Author comment on "Drought-induced non-stationarity in the rainfall-runoff relationship invalidates the role of control catchment at the Red Hill paired-catchment experimental site" by Yunfan Zhang et al., Hydrol. Earth Syst. Sci. Discuss.,
<https://doi.org/10.5194/hess-2021-5-AC1>, 2021

Response to Reviewer #1

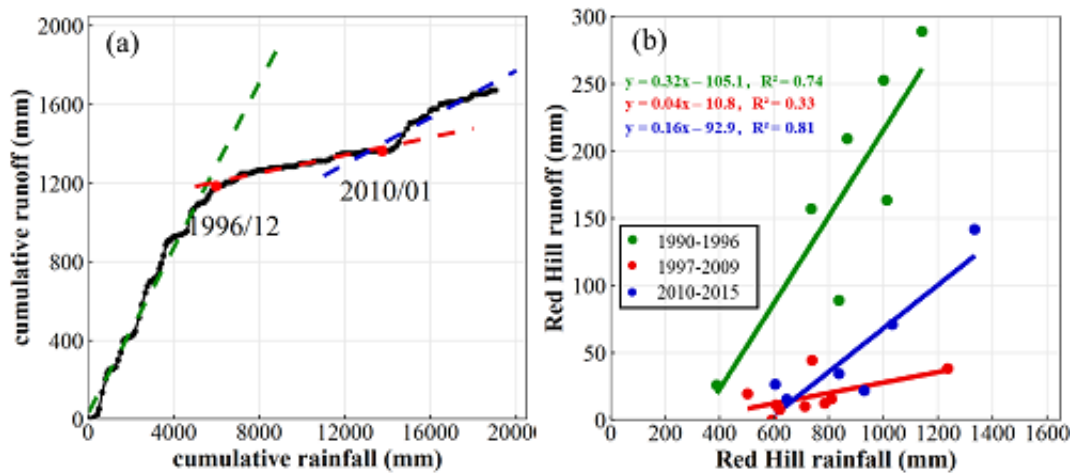
- It's a flaw that the manuscript lacked detection of changes in the rainfall-runoff relationship for the treated catchment. Although it's obvious why there is a control and a treated catchment, I think it's important to apply the appropriate parts of the applied analysis for the treated catchment, also to have a better understanding of the underlying processes; to confirm or to deny the non-linear behaviour of the treated catchment.

A. If the treated catchment has not been reforested, did you expect the treated catchment to show similar behaviour as the control catchment?

B. Does the treated catchment already shows the same non-linearity as the control catchment?

A. If the treated catchment has not been reforested, we expect the treated catchment to show similar behaviour as the control catchment. Because the terrain, meteorology, area of the two catchments are very similar, when the treated catchment is not reforested, the land cover types of the two catchments are also similar, both are grassland. When prolonged drought occurs, the change of hydrological process in two catchments should be similar.

B. Yes, the treated catchment shows the similar non-linearity as the control catchment, as shown in Figure R1 and Figure 5 (Page 39). But observed changes in treated catchment should be driven by two factors, i.e. afforestation and prolonged drought by assuming prolonged drought can lead to changes in rainfall-runoff relationship of the treated catchment.

Figure R2 The variation in monthly rainfall of the Kileys Run catchment (control catchment), New South Wales, Australia, during the periods of 1990–2015.

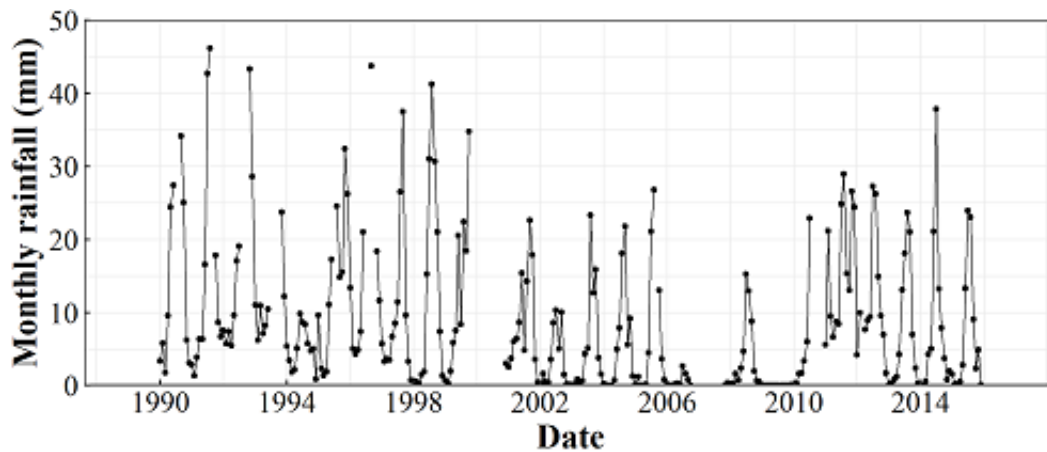
- Lines 139-147; what is the variation in monthly rainfall? Seasonal? What Köppen climate?

The variation in monthly rainfall can be seen in Figure R2. Seasonal changes in monthly rainfall can be seen in Figure R3. The monthly rainfall decreased greatly during the period of 2001-2009 and increased after 2010, but is still less than the monthly rainfall before 2001. There is more precipitation in winter (June, July and August), but the difference amongst rainfall of four seasons is small. The climate type in Kileys Run and Red Hill

Figure R4. (a) Monthly runoff at control (Kileys Run) vs. treated (Red Hill) catchments in New South Wales, Australia, during the calibration period, and (b) Monthly rainfall vs. runoff of the treated catchment during the calibration period. Dashed line is the 1:1 line.

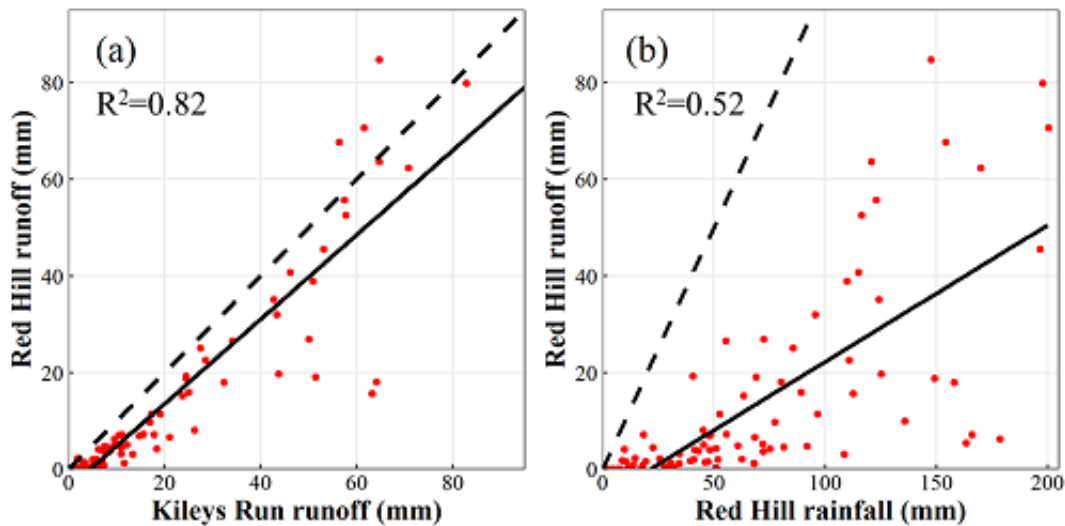
- Figure 4. A. The left figure is Kileys Run, but in the caption you mention Red Hill first, change either the caption or the figure order. B. The x- and y-axis do have different ranges, this makes the graphs difficult to compare and to understand the meaning of the results.

Reply: Thanks for your helpful suggestions. Figure 4 will be replaced by Figure R4 in revised manuscript as follows:

A. The title of Figure 4 has been changed to that of Figure R4.

B. The runoff-runoff relationship for the two paired catchments in Figure 4 (a) is used in the paired catchment method, and the rainfall-runoff relationship of the treated catchment in Figure 4 (b) is used in the time-trend analysis method.

Figure R5. Daily flow duration curves of the Kileys Run catchment (i.e., control catchment), New South Wales, Australia, over four different periods (see legend).

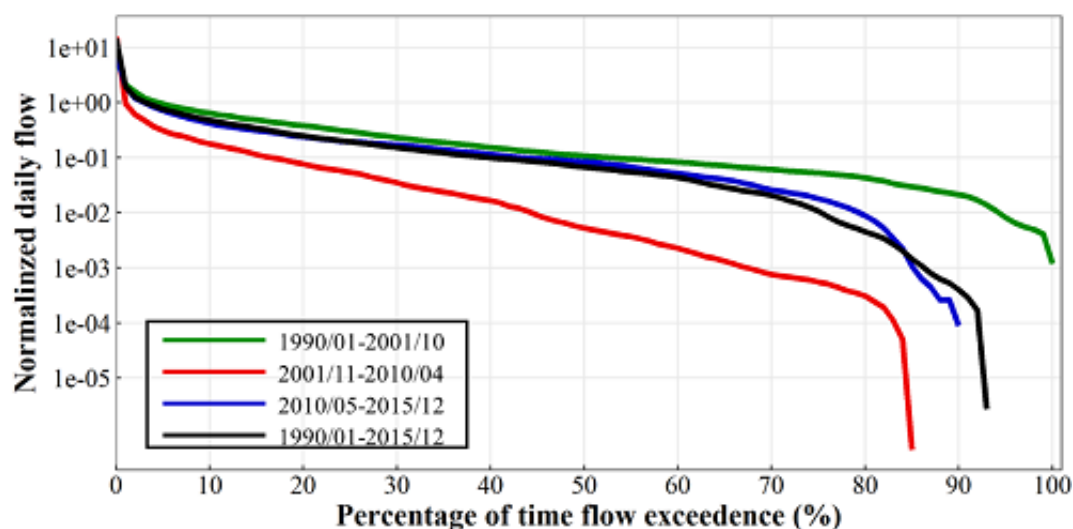
- Figure 6; you may consider add the daily flow duration curve for the entire measurement period (1990-2015) to indicate the differences;

Reply: Thanks for your helpful suggestions. The daily flow duration curve including the entire measurement period (1990-2015) can be seen in Figure R5.

The FDC of the entire measurement period (1990-2015) is close to the FDC of the third period (2010-2015). There is 6% no-flow days during the whole period. In the first period (pre-drought), the second period (after drought) and the whole period (including the whole drought period), high flows have a highly consistent change, but the difference amongst low flows is significant. It indicates that the impact of prolonged drought on the low flow is more serious than that of the high flow. When the rainfall increases, the high flow may recover quickly, but the low flow may recover slowly.

Figure R6. Estimated monthly values of parameters (a) C and (b) SC used in the two-parameter monthly water balance model for the Kileys Run catchment (control catchment), New South Wales, Australia, during the period of 1990–2015.

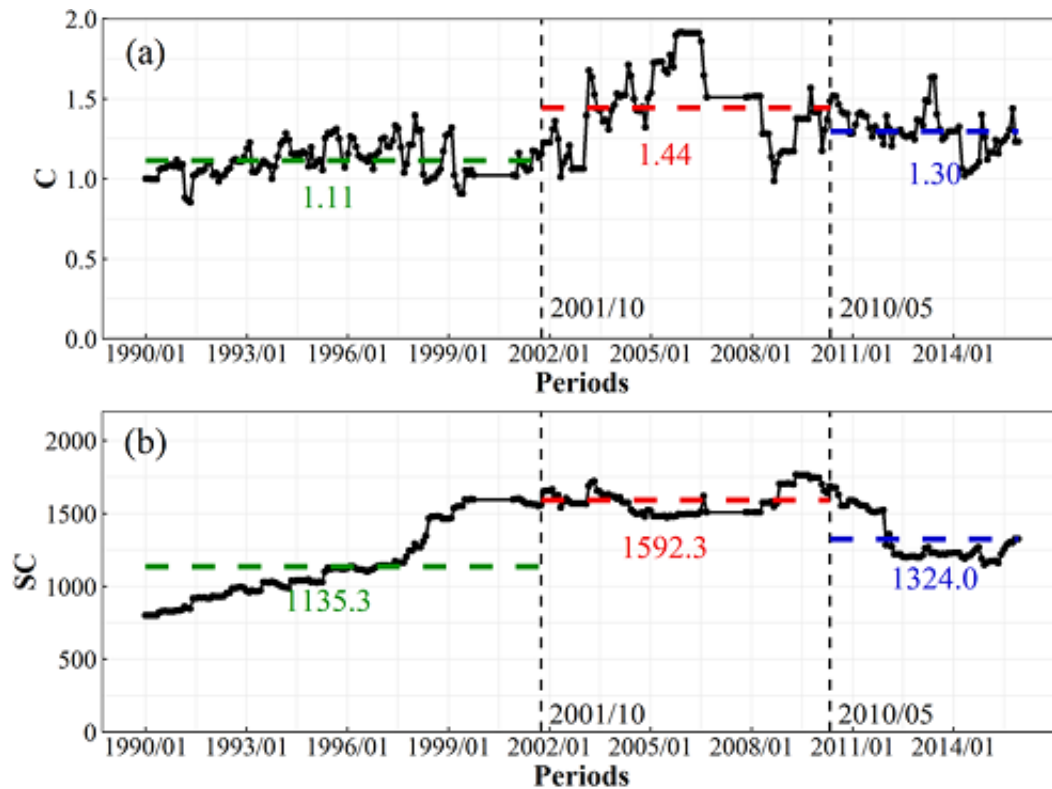
- Figure 7; The x-axis of the graphs could be better aligned;

Reply: Thanks for your helpful suggestions. Figure 7 will be replaced by Figure R6.
